Palo Verde Nuclear
Generating Station

Subject: Palo Verde Nuclear Generating Station (PVNGS)
Units 1, 2, and 3
Docket Nos. STN 50-528, 50-529 and 50-530
Amendment No. 1 to License Renewal Application: Revised
Environmental Report Figure 3-2 and Table 4-2 for the Hassayampa
No. 3 Transmission Line

Palo Verde Nuclear Generating Station License Renewal Application Amendment No. 1

Appendix E Environmental Report Figure 3-2
Appendix E Environmental Report Table 4-2

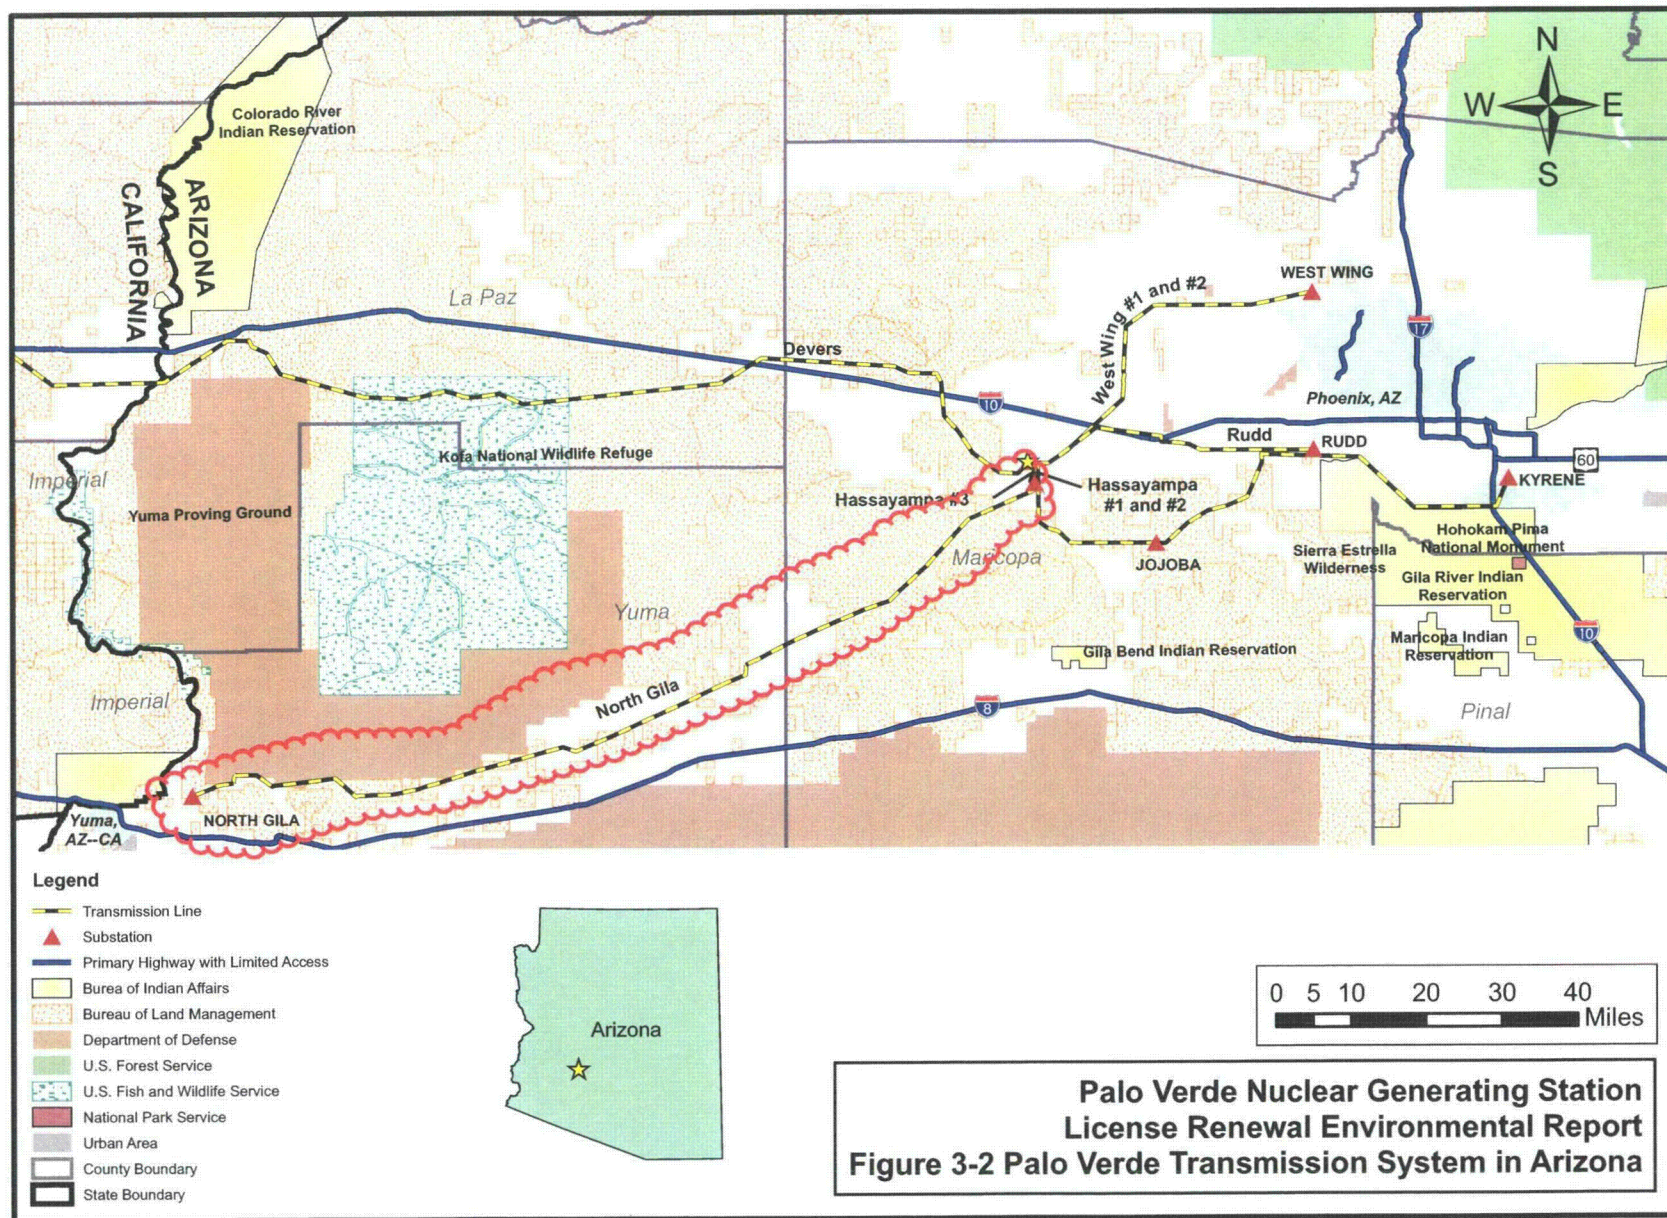
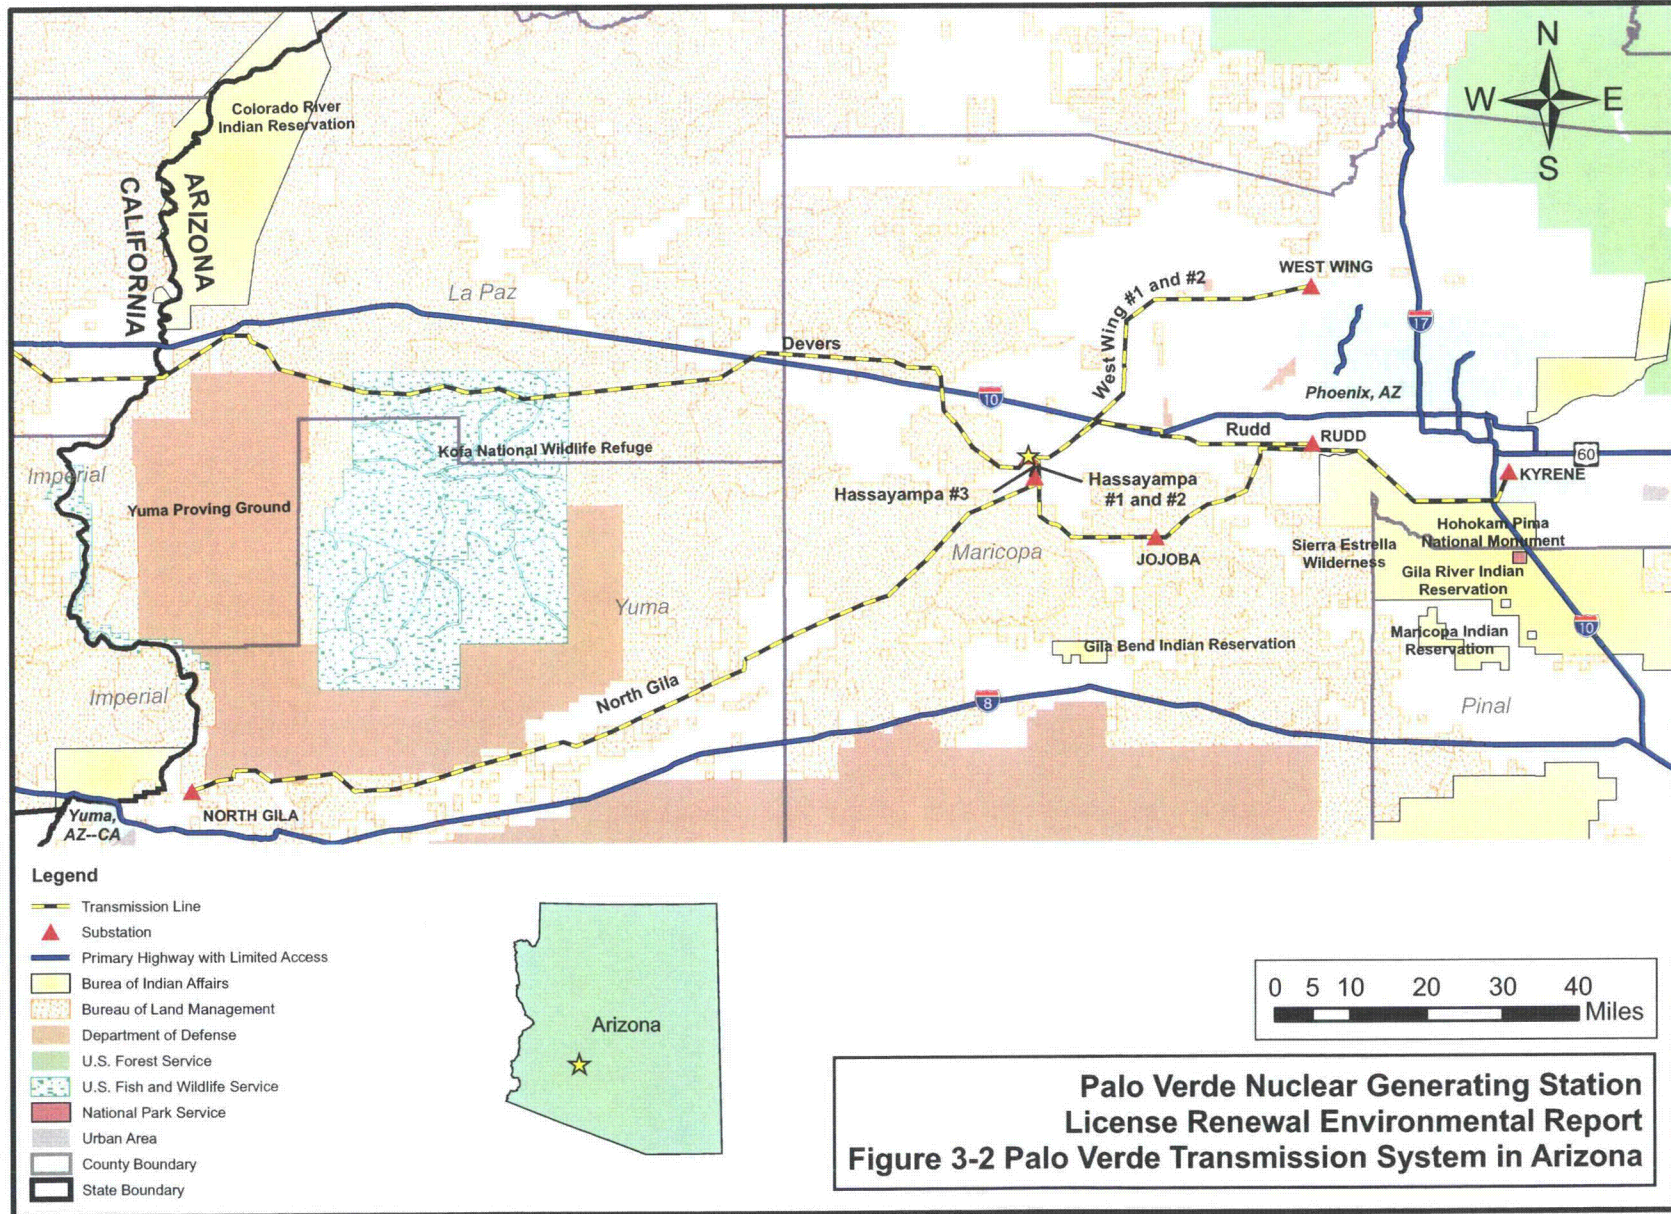
Accordingly, Amendment No. 1 to the PVNGS LRA containing the revised ER Figure 3-2 and Table 4-2 that reflect the North Gila transmission line is enclosed. Figure 3-2 was updated to depict the North Gila transmission line and Table 4-2 was updated to note that the Hassayampa No. 3 induced current analysis includes the North Gila transmission line. As described in ER Section 3.1.3, the North Gila line has been included in the Hassayampa No. 3 analyzed distance because the North Gila transmission line from PVNGS to the North Gila substation was constructed and placed into service in 1984 (prior to issuance of the PVNGS full power operating licenses). A new substation was constructed at Hassayampa in 2001 and the North Gila line was connected to this substation. The short connection between PVNGS and Hassayampa that originally connected to North Gila became identified as Hassayampa No. 3.

APS has notified the U.S. Fish and Wildlife Service and the Arizona Game and Fish Department of the revised Hassayampa No. 3 transmission line analyzed distance in Figure 3-2, since Figure 3-2 had been provided to them in letters dated September 28, 2007 (ER Attachment B).
